Planning and Zoning Special Meeting AGENDA

Tuesday, March 30, 2021 at 4:30 PM
Ketchum City Hall
480 East Avenue North, Ketchum, ID 83340

3. ACTION ITEM: Amendment to P18-131 - Swan Streambank Alteration: 401 Northwood Way (Lot 12, Chateau of Northwood), owned by Bob and Sandra Swan, and adjacent riverbed (Ketchum FR NWSE TL 7801 SEC 12 4N 17E River Bed) owned by the City of Ketchum. The Commission will consider a proposed amendment to Floodplain Development / Stream Alteration permit P18-131, the Swan Stream Alteration/Bank Stabilization Floodplain Development and Waterways Design Review Permit. *Continued from March 9, 2021, March 23, 2021*

4. ACTION ITEM: Deep Powder Townhomes Design Review and Townhouse Subdivision Preliminary Plat: 255 Hillside Drive (Warm Springs Subdivision #5: Block 2: Lot 33) The Commission will consider Mountain Overlay Design Review and Townhouse Subdivision Preliminary Plat applications for a new two-unit detached townhome development located within the City's General Residential Low Density (GR-L) Zone and the Mountain Overlay and Avalanche Zone. *Continued from March 23, 2021.*

5 CHANNEL STABILIZATION SILL
1 2 SCALE: N.T.S.

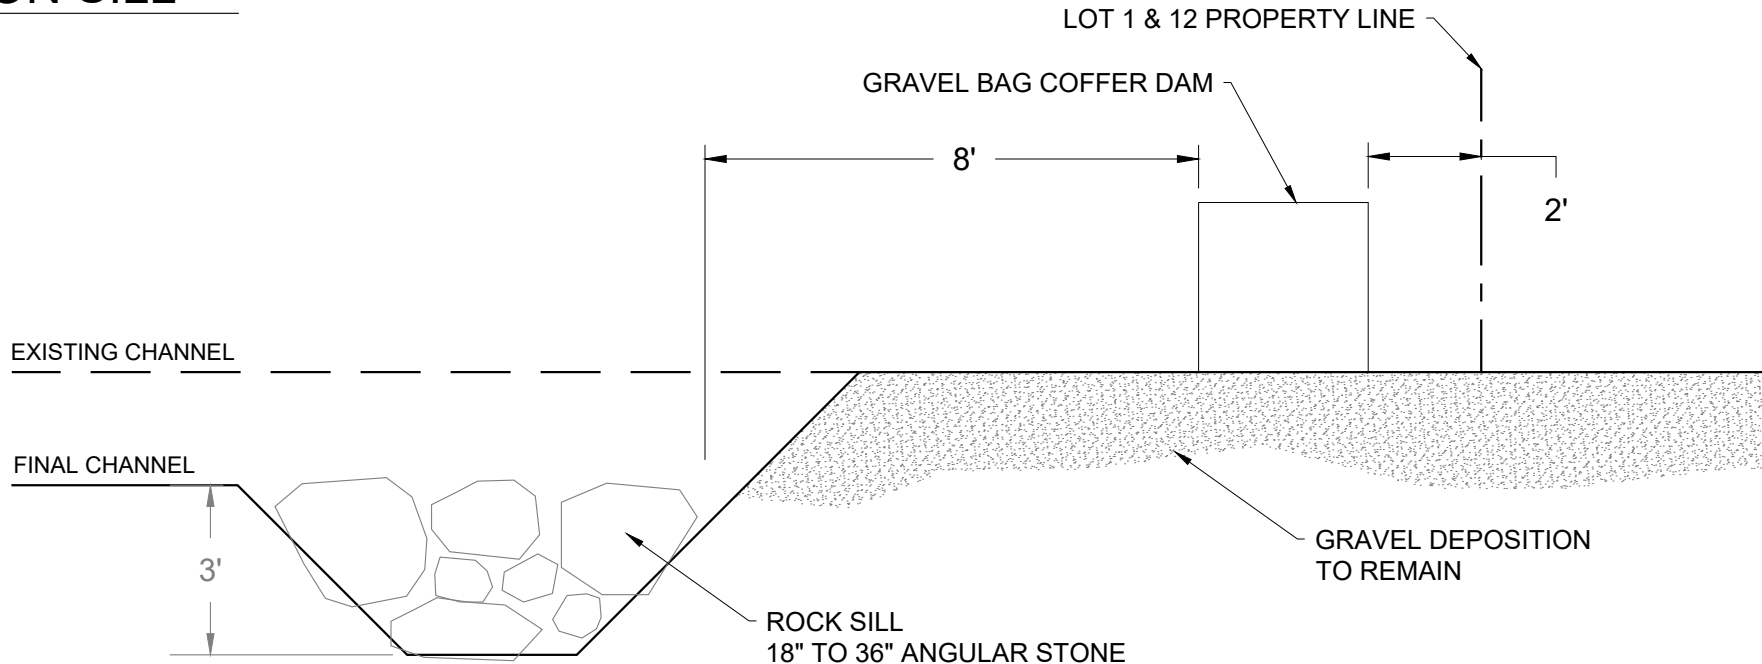
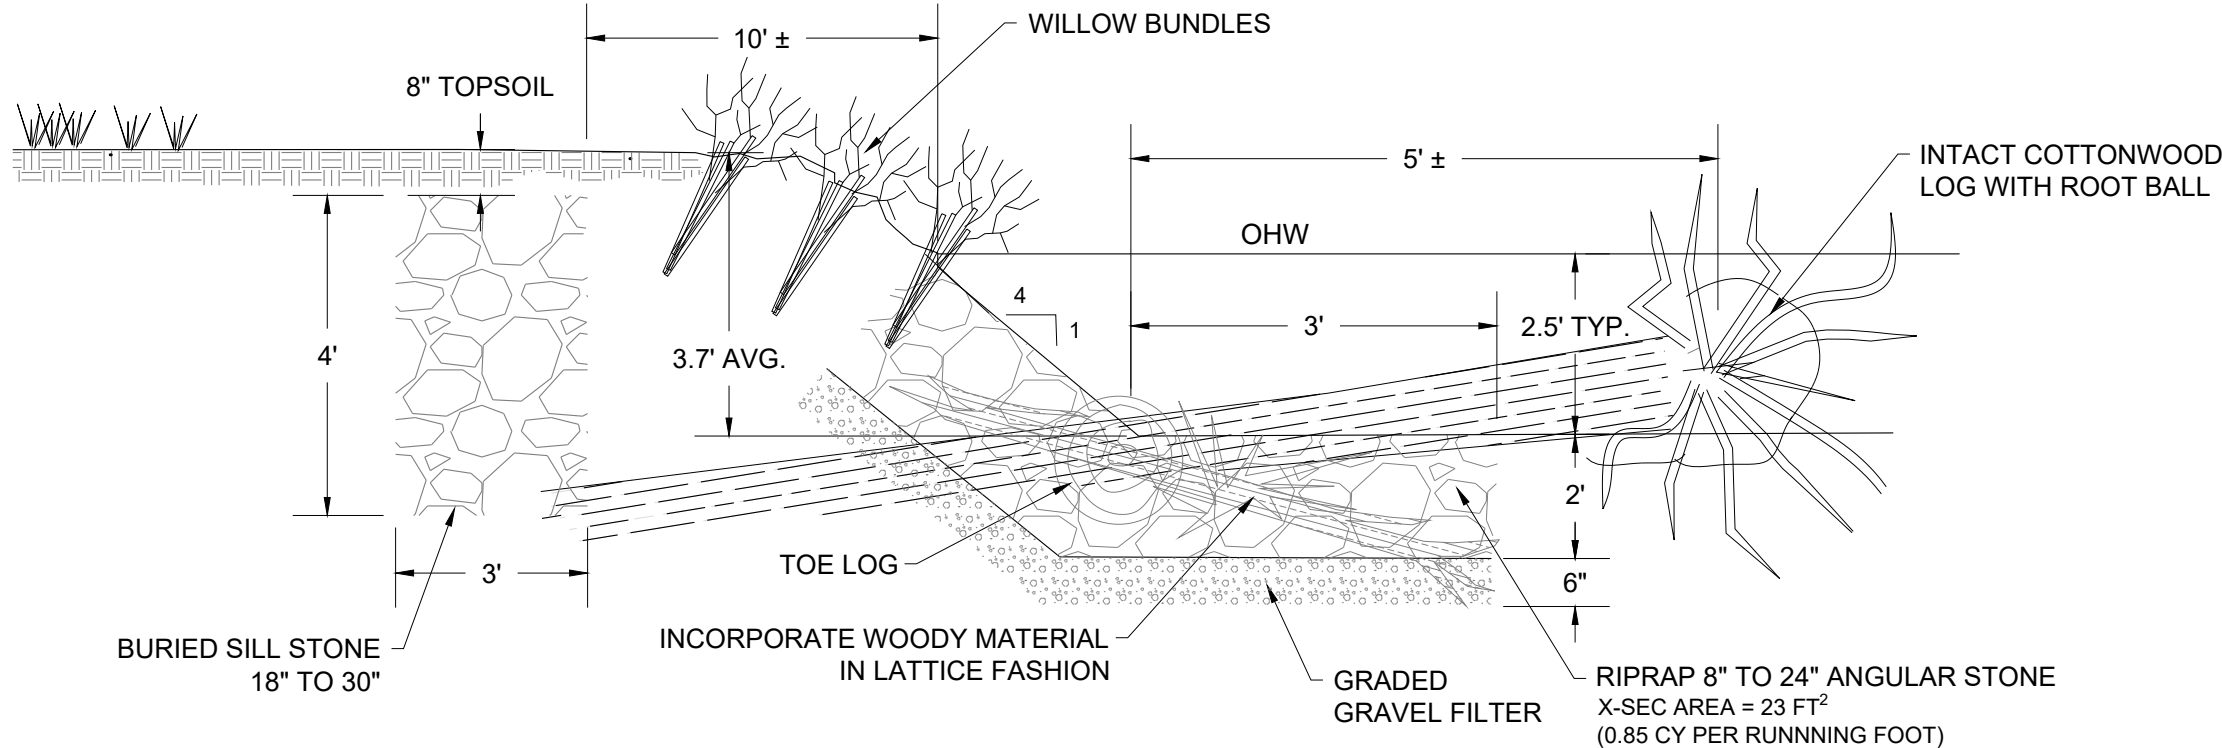
The Swan project amendment proposes a sill across the channel at the owner's north property line. The City of Ketchum has requested additional information about the nature and functionality of a sill and the justification for it.

D R A W I N G :
SITE PLAN

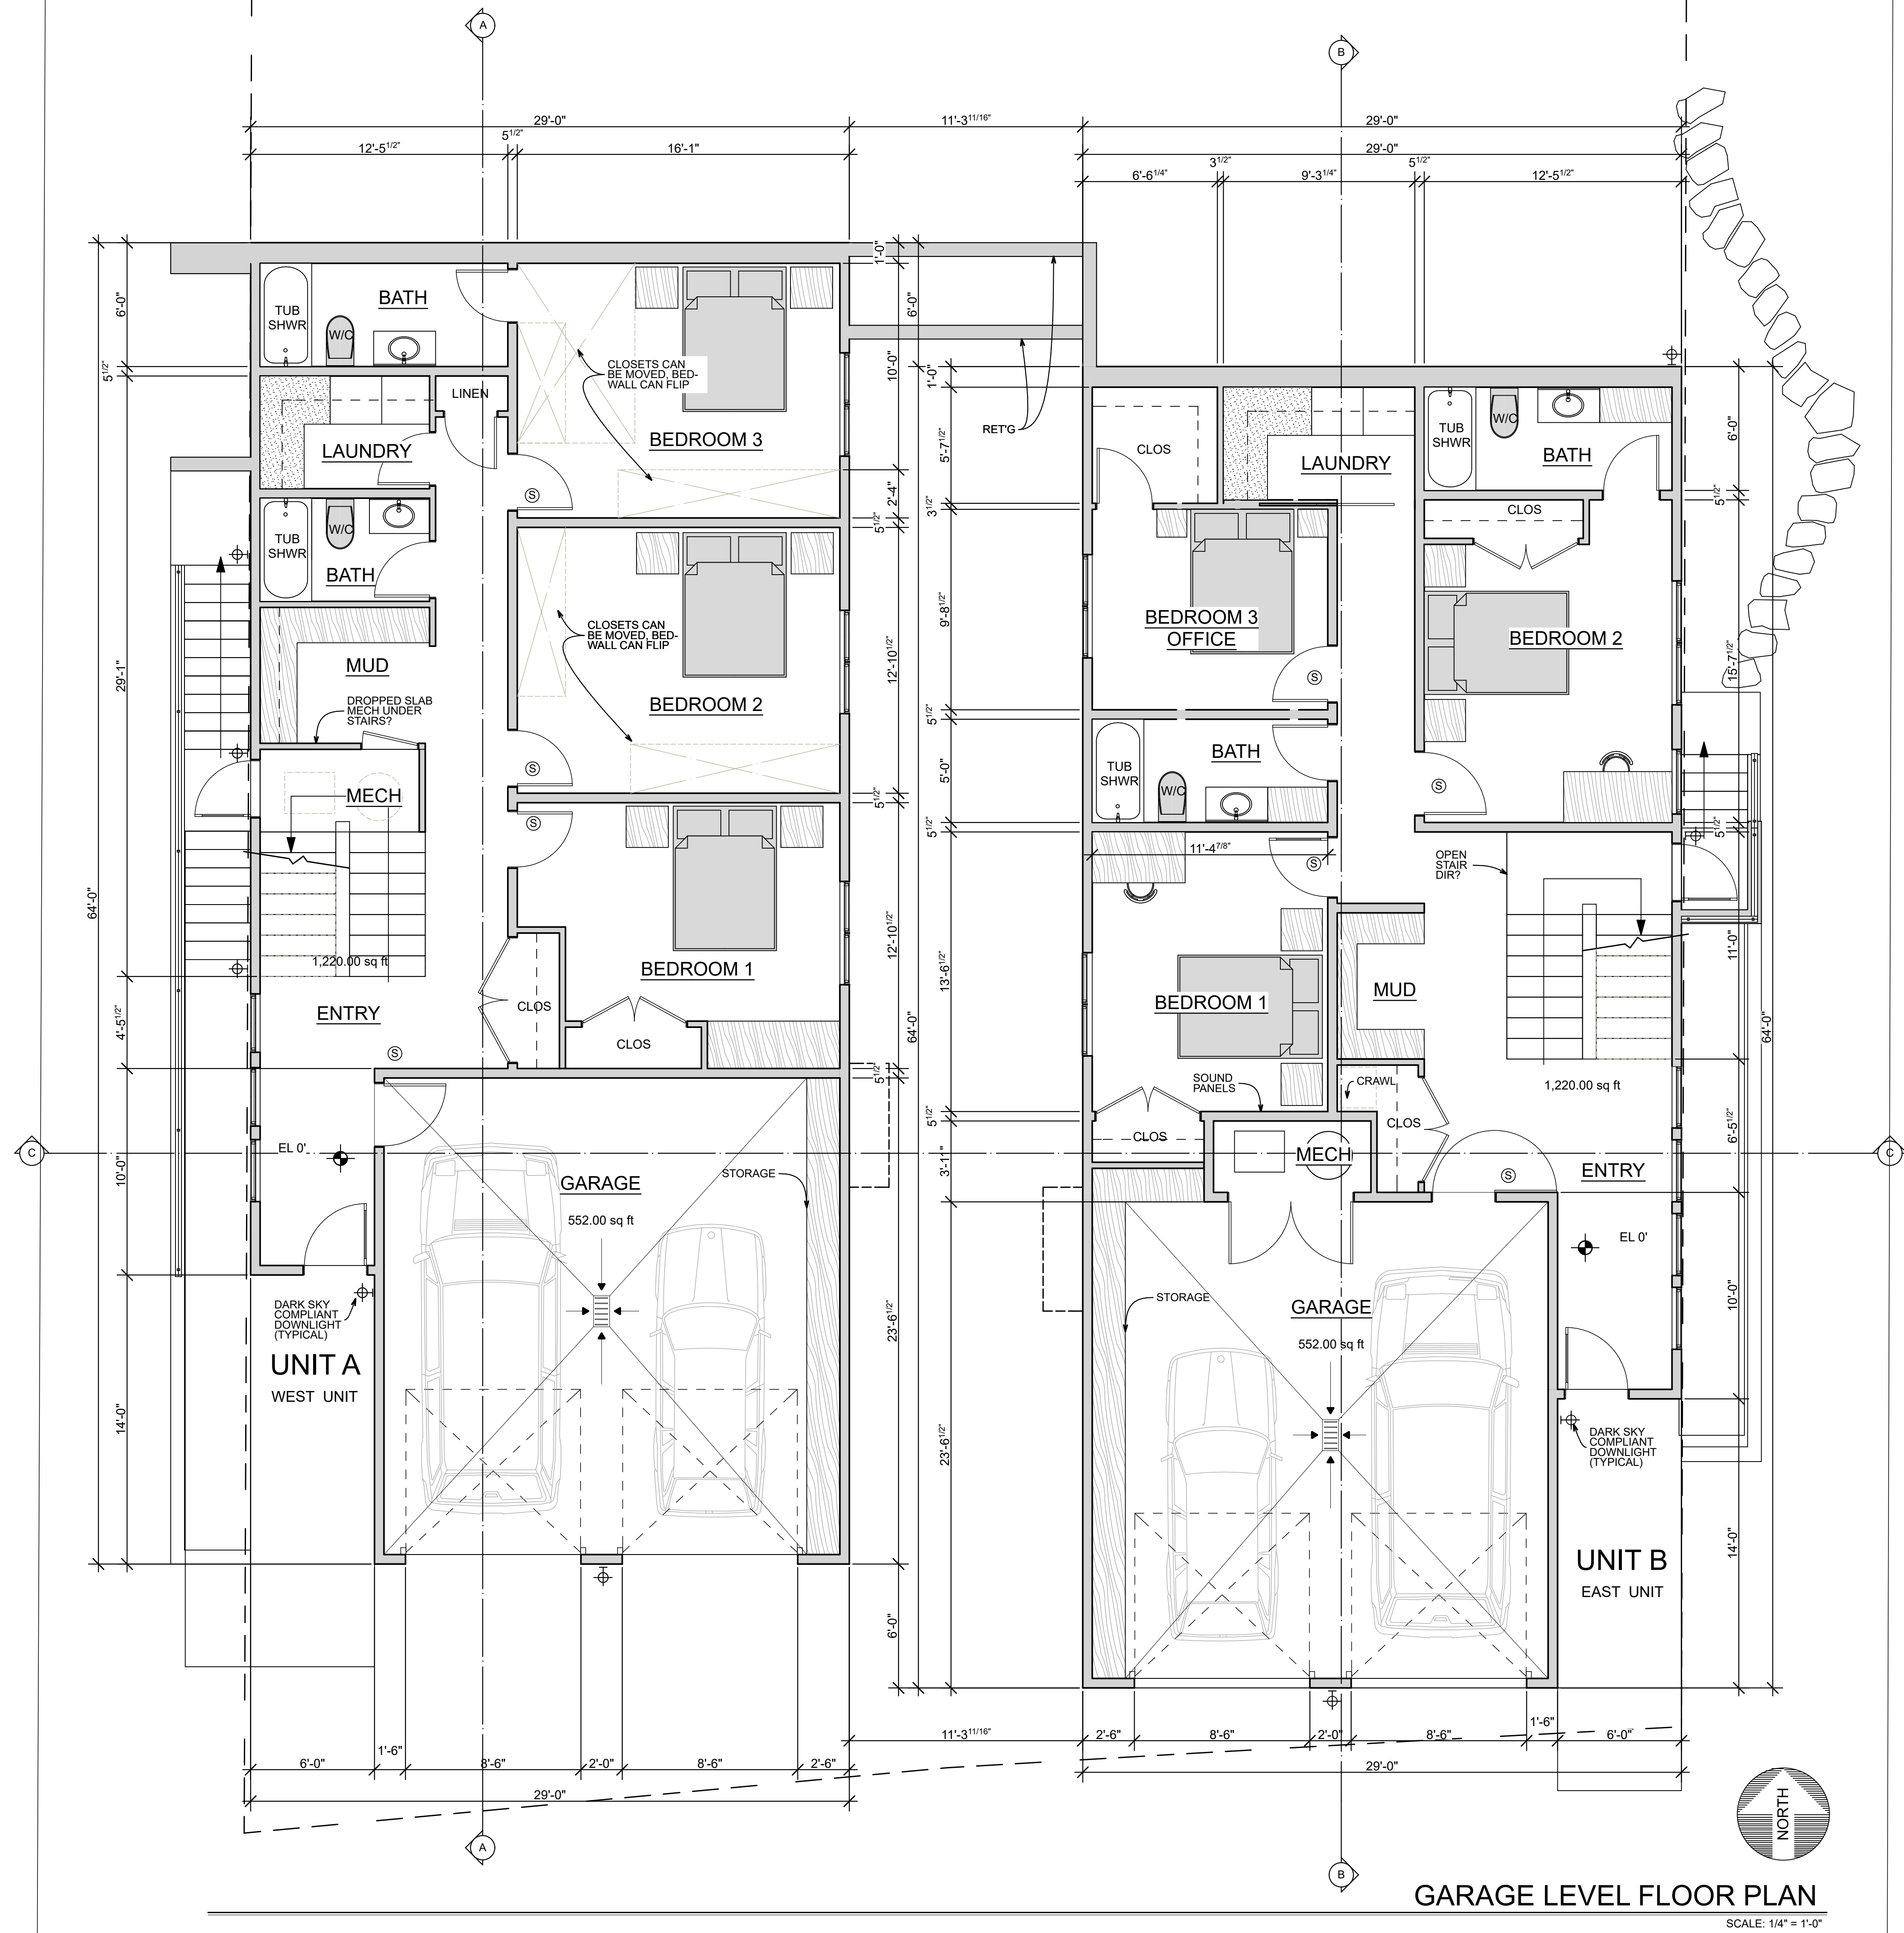
1. As they depict on their Site Plan, page A.1.0, their west building sits 10' from our common property line and extends approximately 8' north of our building and 16' south of our building. It is a very long structure.
2. On sheet A.3.0, their building elevations show the 64' length of their west elevation sitting just 10' from our common property line. Their plans contemplate continuing their roof south covering a 14' deck over the garage. This unnecessary imposing roof structure will severely impact and take away light and air from our indoor and outdoor living areas.
